Response to Submissions Report

21, 31 and 42 Hanson Place, Eastern Creek
Resource Recovery Facility

Submitted to NSW Department of Planning,
Industry and Environment
On behalf of Hanson Construction Materials Pty
Ltd

2 December 2021 | 218611

Figure 2 **Recycling Flow Diagrams**

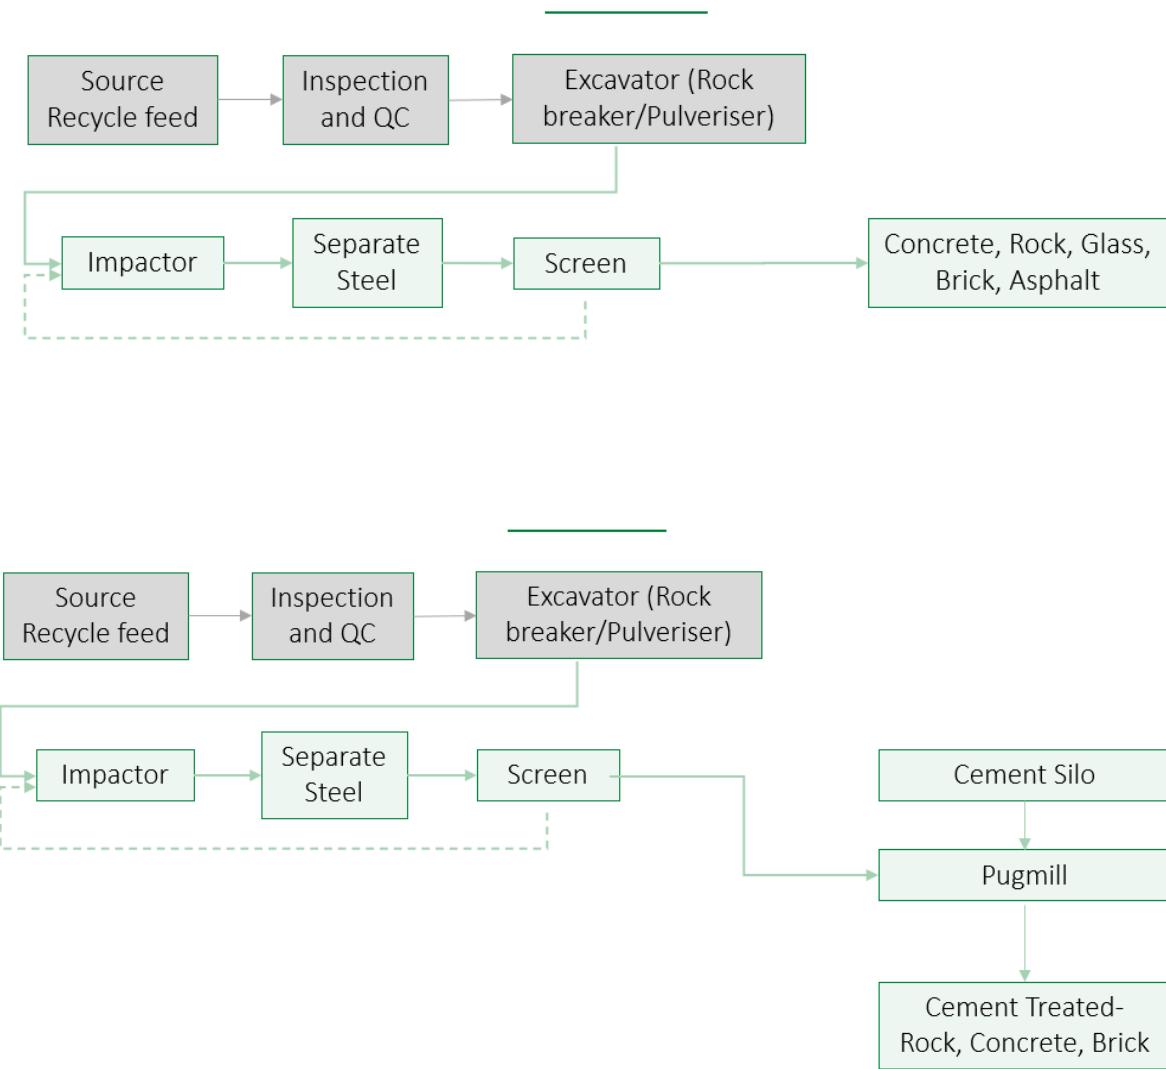
- How each proposed waste stream (concrete, glass, brick, asphalt) is to be processed at the premises: The EPA requires the applicant to provide additional detail for each stream, and flow diagrams for each waste stream.

- Waste stream and flow diagrams for each waste stream are provided at **Figure 2**. There are two flow diagrams provided.
 - The first relates to the normal process where raw feed (comprising rock, concrete, glass, brick, or asphalt) is size reduced by the rock breaker before being passed through the crusher (labelled in the flow diagram as an 'impactor'). The crusher will crush and screen the material to a specified size before discharging into the relevant stockpile area.

- The second relates to the use of the pugmill (see also **Section 4.3.4** below), the only difference being that the rock, concrete and brick once discharged from the crusher can be mixed in the pugmill with water and cement to create aggregate mixes with different specifications in terms of stability and water content.
